**Fire Protection Upgrades
Halifax Elementary School
464 Plymouth Street
Halifax, MA 02338**

**Habeeb & Associates Architects
H&A Job No. 1614.01**

**ADDENDUM NO. 03
February 4, 2019**

SK-1

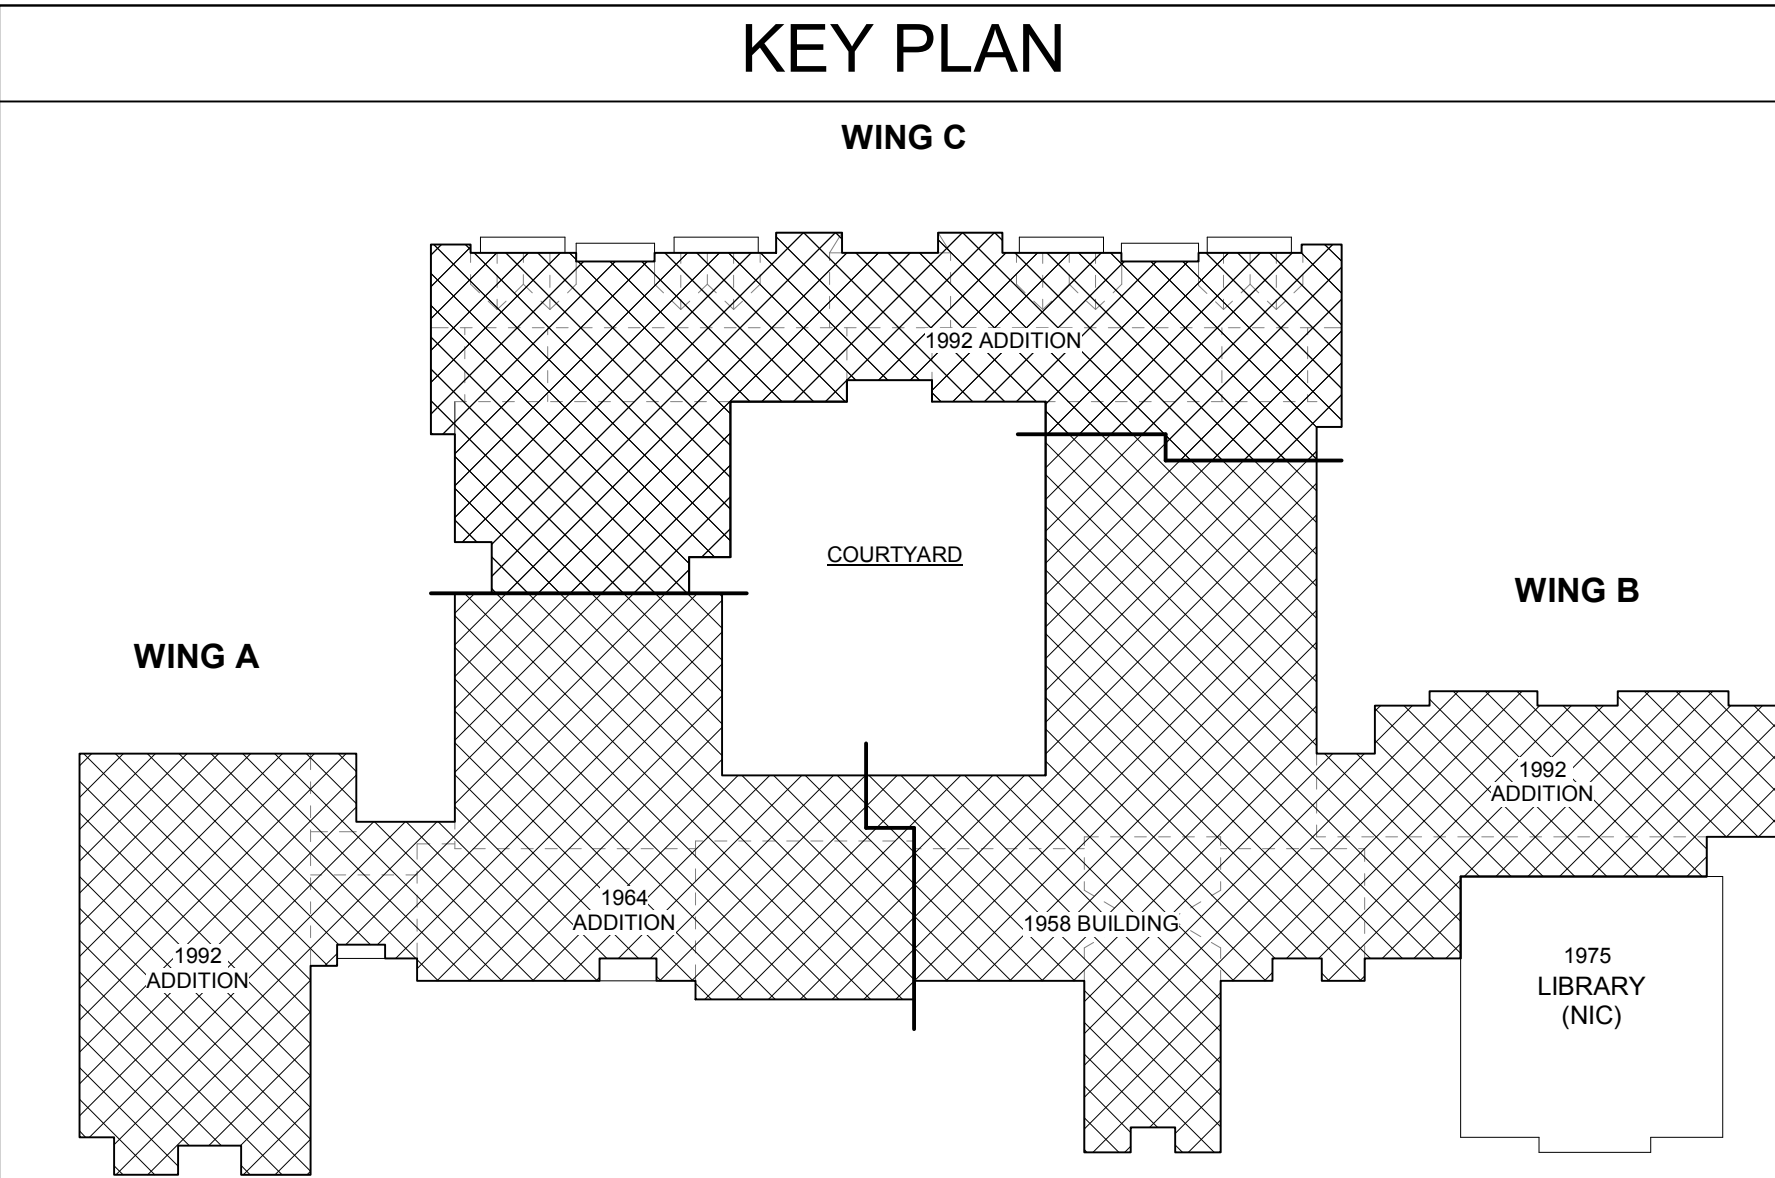
1. **QUESTION:** Regarding Note-3 in Sheet Number A-151 ATTIC PLAN, are we to understand that all of the surface areas highlighted in red are to have spray foam applied directly to the underside of the roof deck? If not please clarify where the foam is to be sprayed.

RESPONSE: The areas shown in red on the marked up attic plans are incorrect. New spray foam insulation is only required at the eave conditions. A previous project done in 2017 added vented nailboard with poly-isocyanurate insulation to all of the roofs above the roof deck. Refer to the attached SK-1 for clarification of the eave locations.

RESPONSE: The whole roof does not need to be sprayed. Just the areas along the eaves shown in the black triangular areas and as shown on the attached sketch SK-1.

ATTIC PLAN

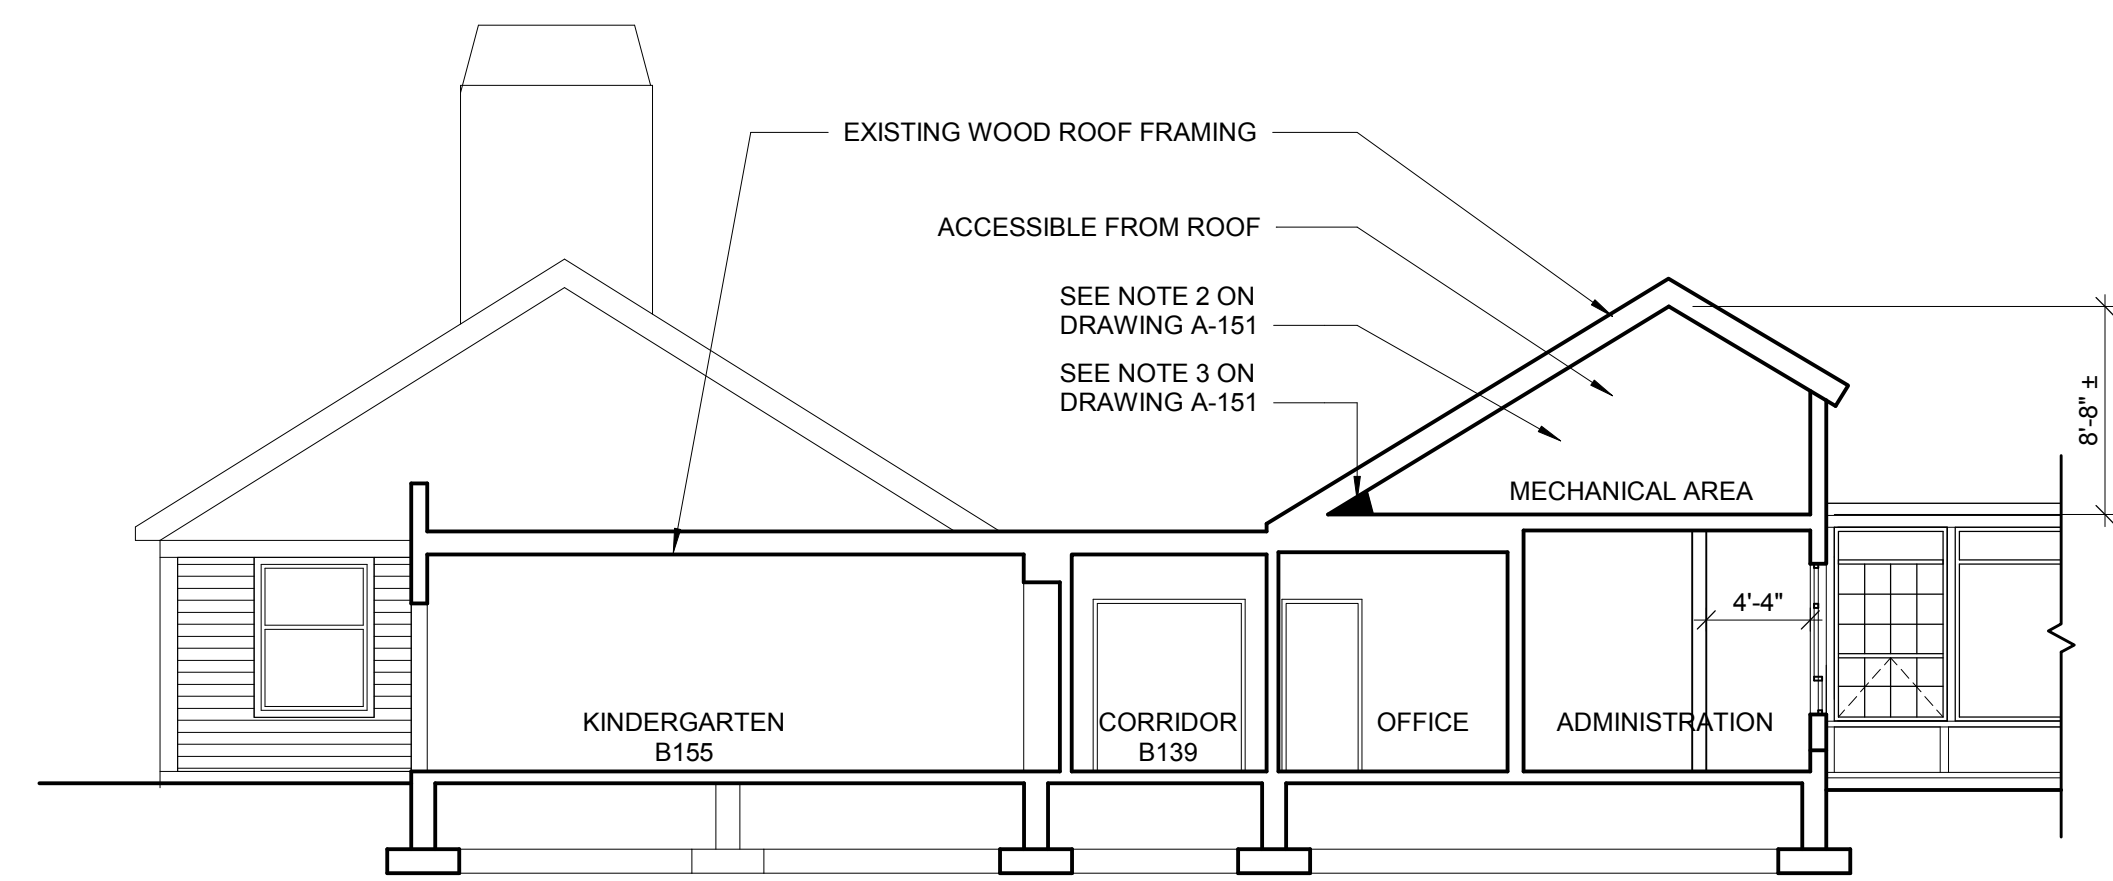
2. **QUESTION:** Regarding Note-3 in Sheet Number A-151 ATTIC PLAN, what is the R-VALUE required for the 4" thickness spray foam?

RESPONSE: R-20
